ADDENDUM NO. 02 TO THE BID DOCUMENTS

Bid Number: 2020-15-75
City Hall Roof Rehabilitation Project
Addendum Date: October 9, 2020

5. Questions and Responses.
6. Exhibit 1: Drawing relating to 1F.

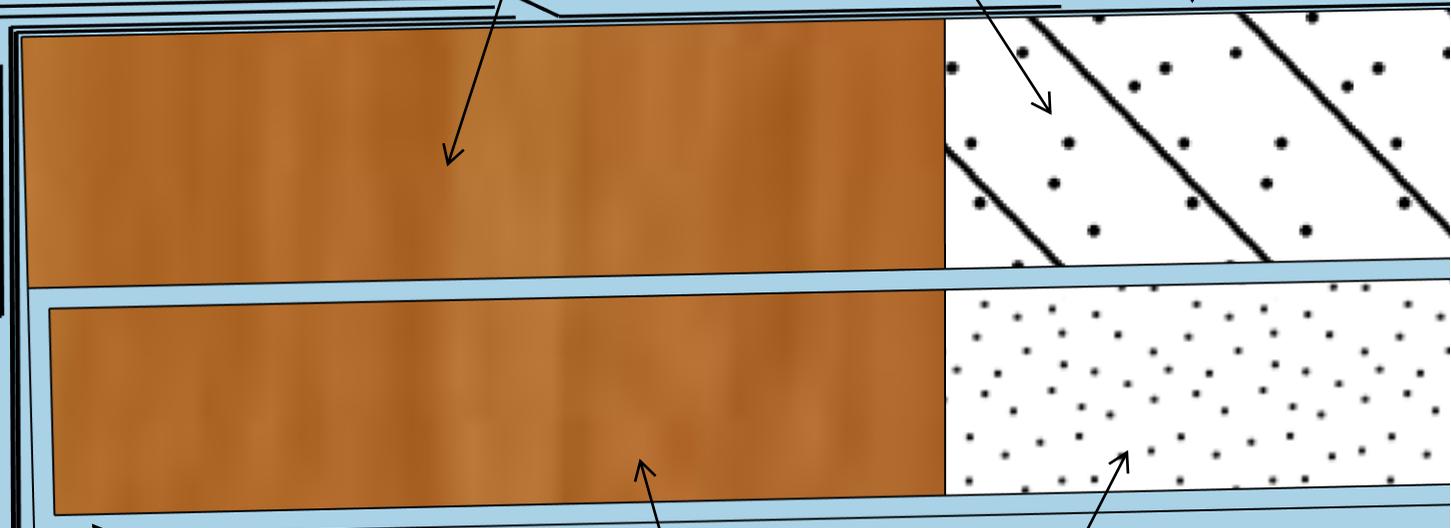
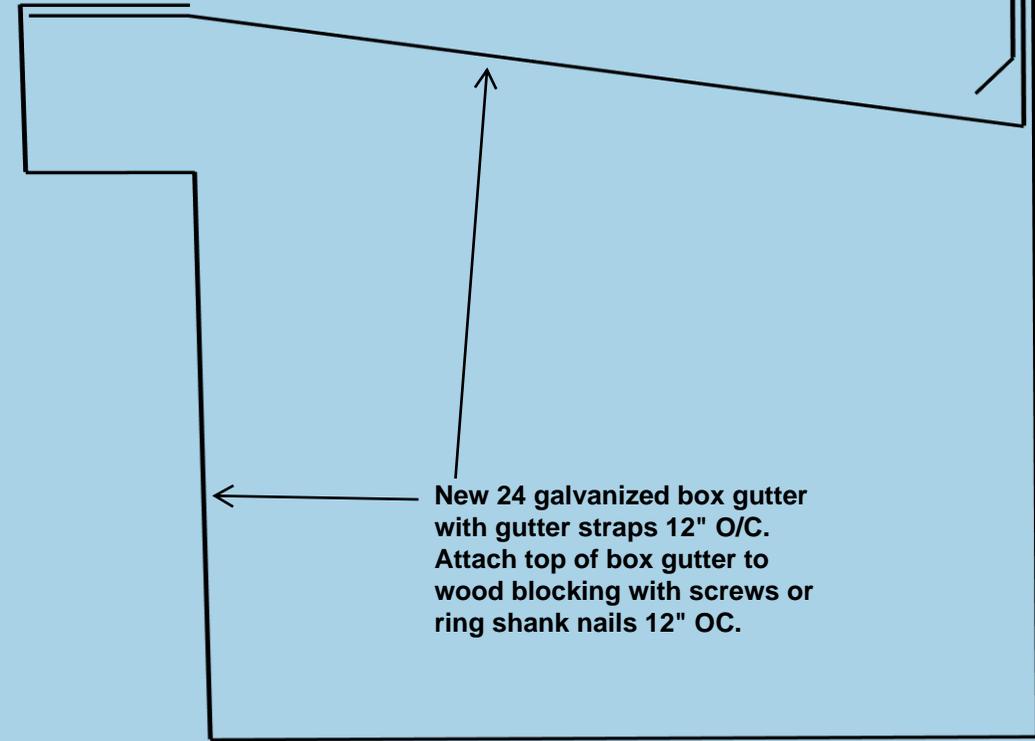
3. **Line item F refers to cutting back the rake edge. The rake edges have parapet walls. The assumption gathered is to cut back the eave edge, which does not seem logical. The scope does not specify what type of flashing to use at the eave edge. There are several options to choose from. Please clarify by specifying the type of gutter edge is required.**

Heat weld strip flashing to clad coated metal and field membrane

New 1.5" EPS board or ISO board in lieu of 1" and utilize a 2x at the perimeter that is the same thickness as the board.

Wrap membrane to face of wood blocking.

Install clad coated drip edge metal at gutter edge fasten top of drip edge with screws or ring shank nails 12" OC. Fasten face of drip edge to wood blocking with long life gasket screws 12" OC. Apply butyl tape to backside face of drip edge.

Cut existing metal roof back to face of building.

New EPS flute filler with wood blocking attached to existing structural purlin.

Refer to Addendum No. 02, the revised Scope of Work, and Exhibit 1.

- E. The Contractor shall saw-cut new counterflashing 12" up interior wall and terminate new Duro-Last roofing.
 - F. The Contractor shall utilize two (2) layers of wood blocking, with the first layer of wood blocking attaching directly to the existing structural purlin; then, attaching a second layer of wood blocking to the first 12" OC (on center), as shown on the attached Exhibit 1.
